- B. VARIANCE REQUEST, WALSH COLLEGE c/o VALERIO DEWALT TRAIN ASSOCIATES, 3838 LIVERNOIS – In order to construct modifications to the existing building: 1) a 10 foot variance to the 25 foot maximum allowed building height; 2) a 5.15 foot variance to the required 80 foot setback from adjacent residential property; and 3) a 4 foot variance to the maximum permitted 35 foot height limit for proposed rooftop mechanical equipment screening structures.

WALSH COLLEGE LIVERNOIS ROAD AND INTERIORS 3838 LIVERNOIS RD. TROY, MI 48083

Preliminary Site Plan Review For City of Troy, Michigan

SHEET NUMBER
C1-01

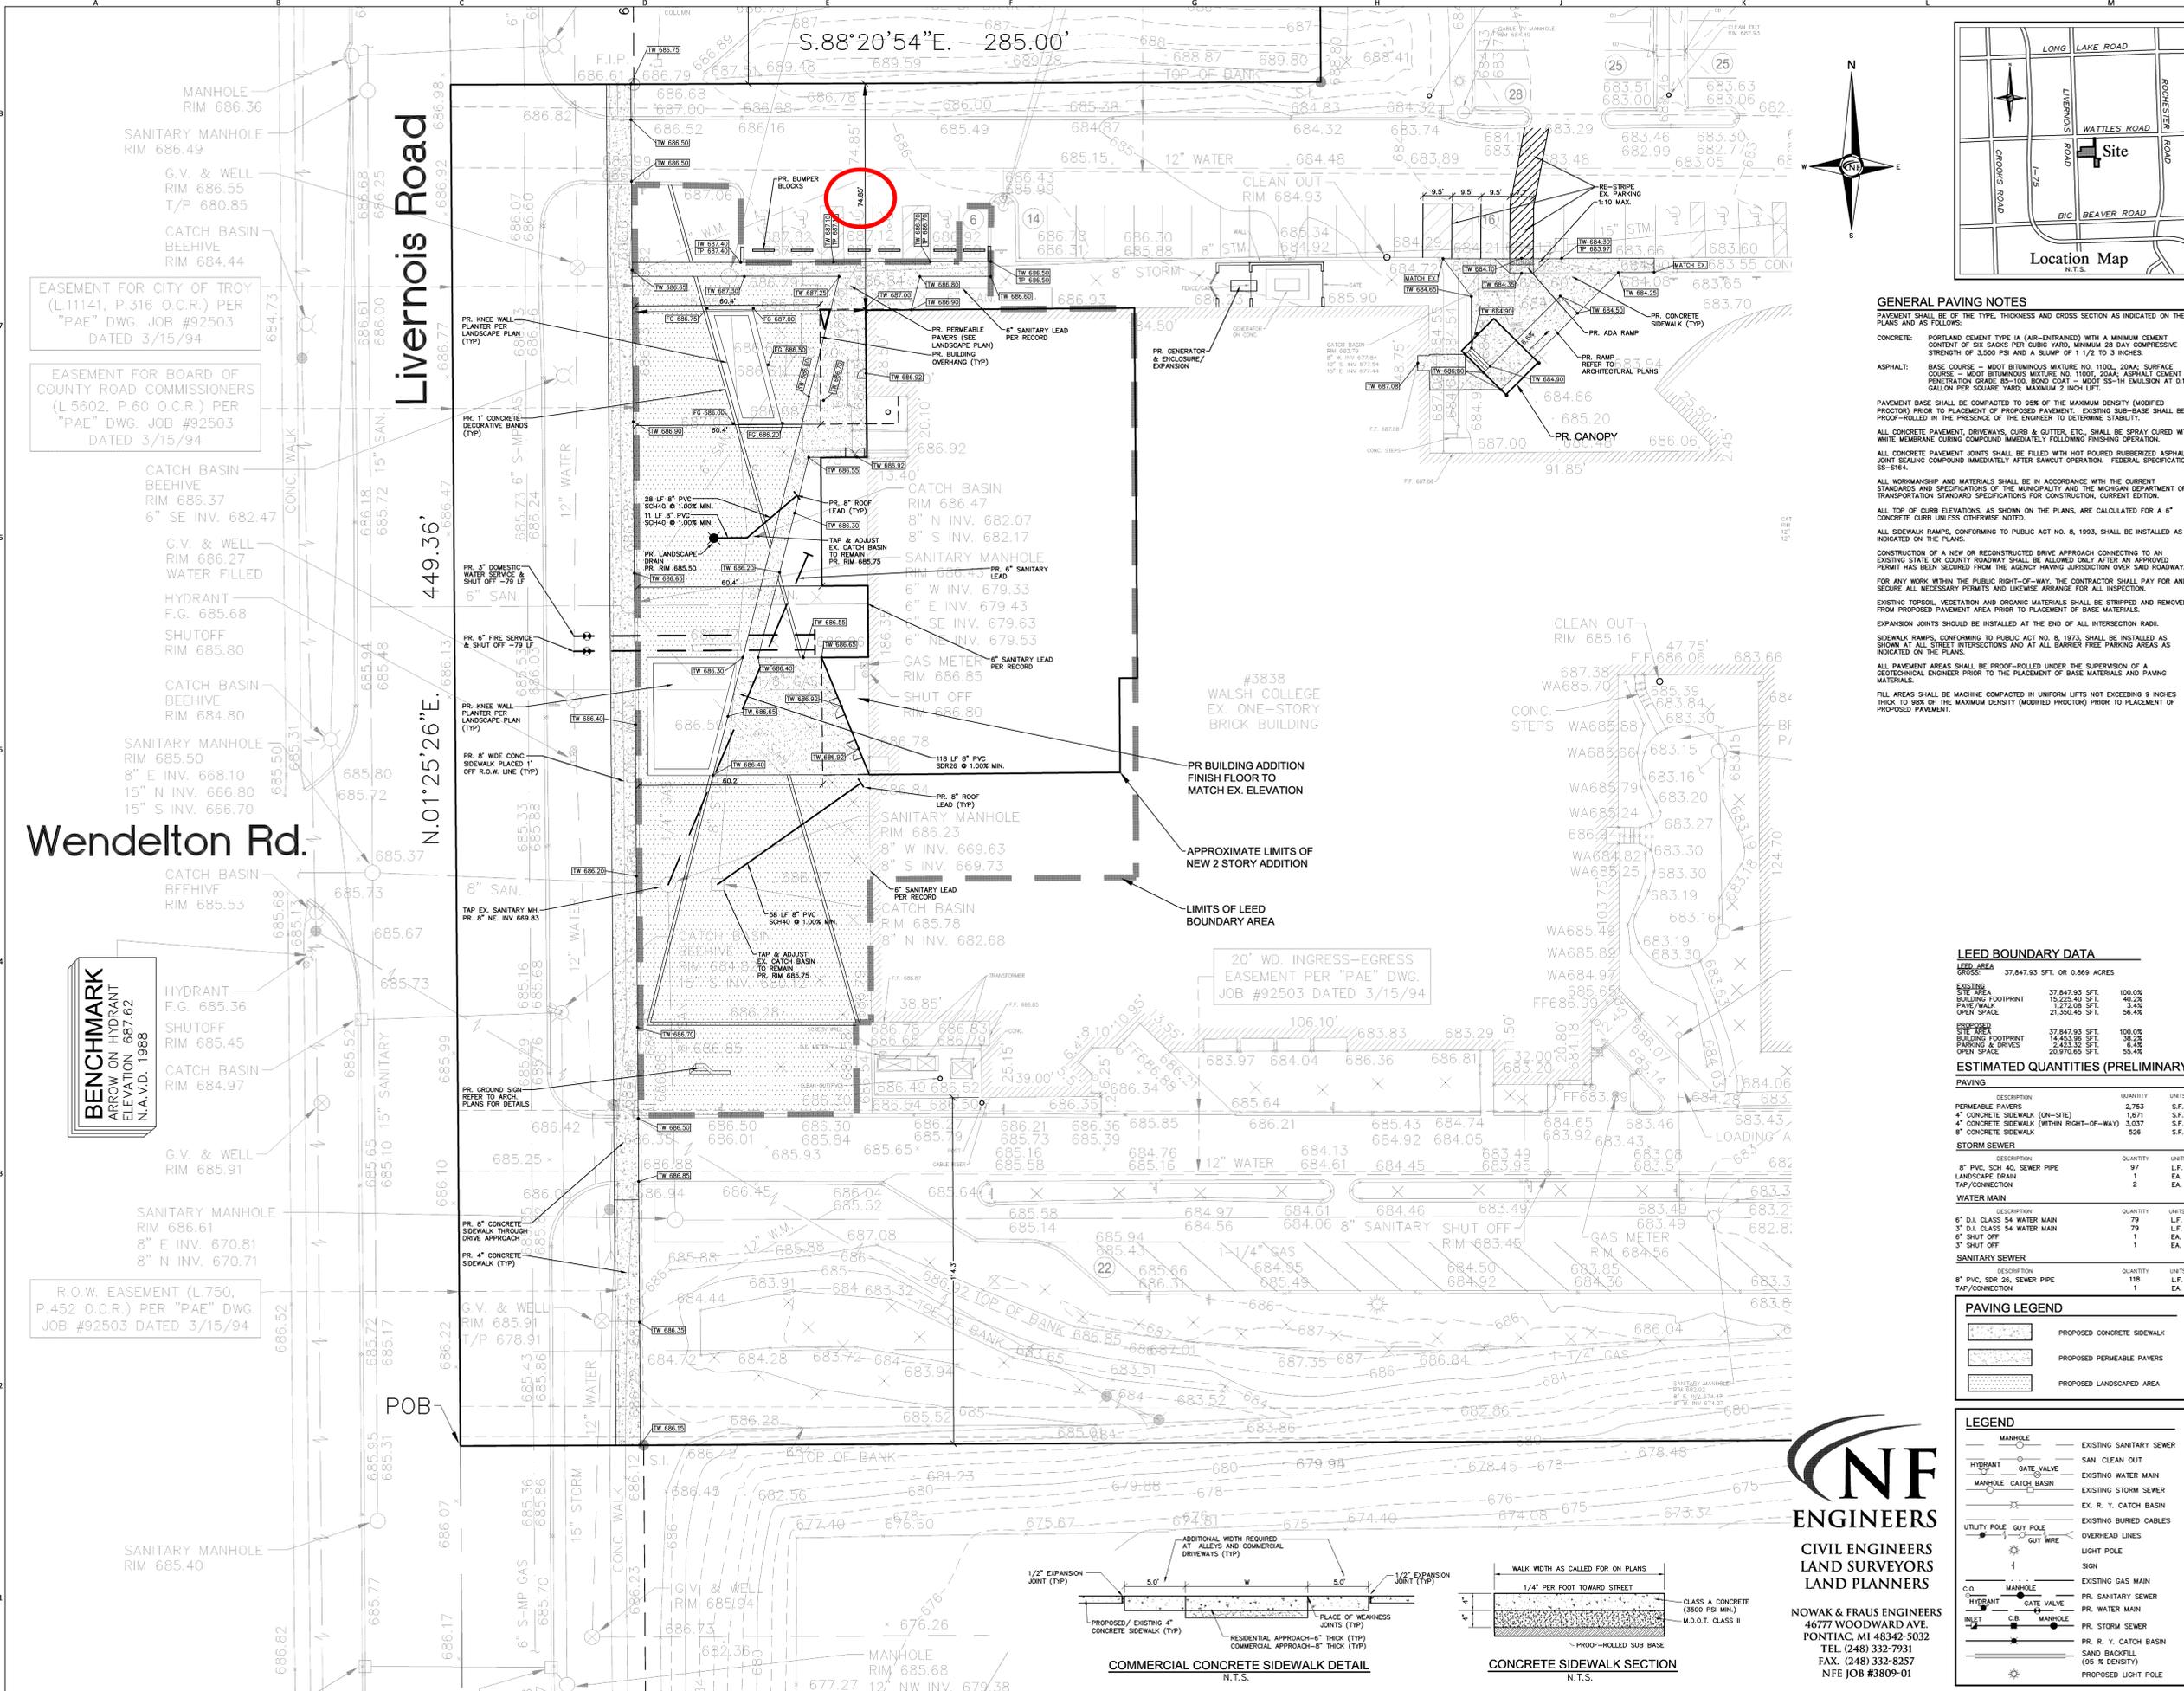
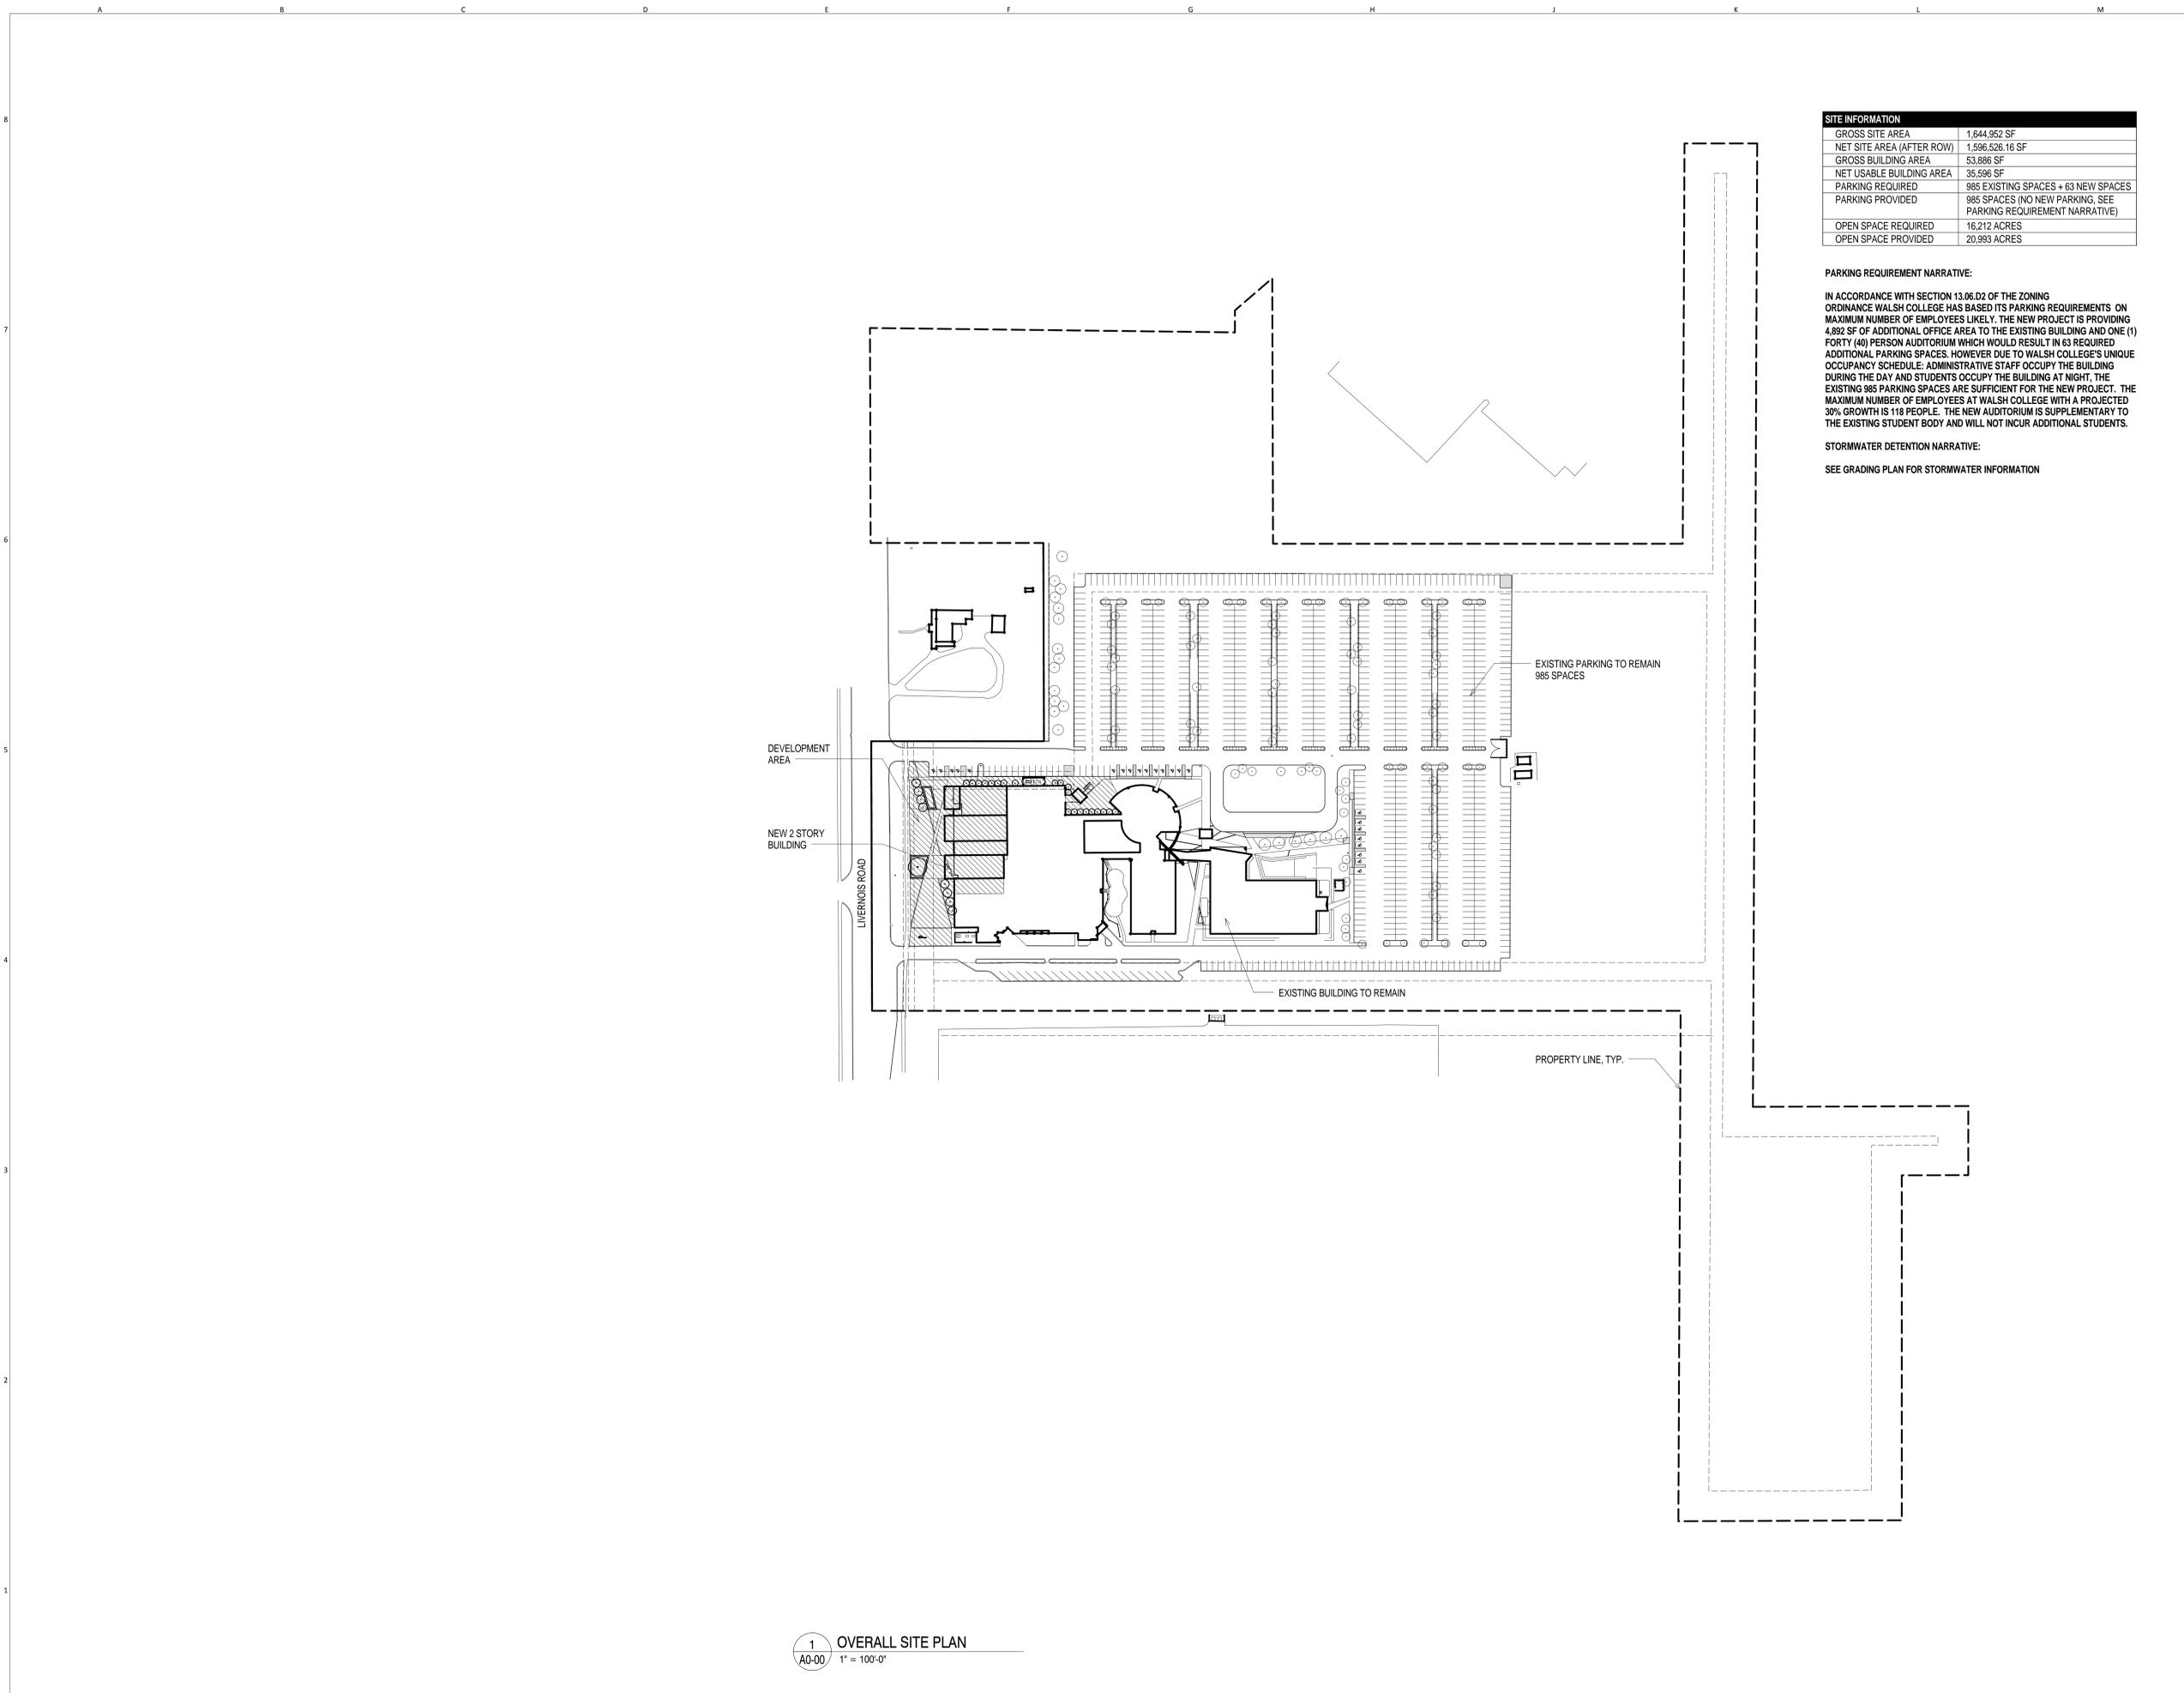
1. Section 6.22.B, states, that no post-secondary school building shall be closer than eighty (80) feet to any property line that is residentially zoned or used.

The applicant is not increasing the encroachment on the northern property line, however because they are adding a second story to the existing one story structure they need to obtain a variance to encroach 5.15 feet into the northern property line.

Height in the Community Facility Zoning District is limited to 25-feet. The applicant will need to obtain a variance to exceed the maximum height of 25 feet by 10 feet for a total building height of 35 feet. It is worth noting that the allowable height in the adjacent R1-C District is 30-feet.

Items to be addressed: 1). Obtain a setback variance from the Zoning Board of Appeals; and 2). Obtain a height variance from the Zoning Board of Appeals.
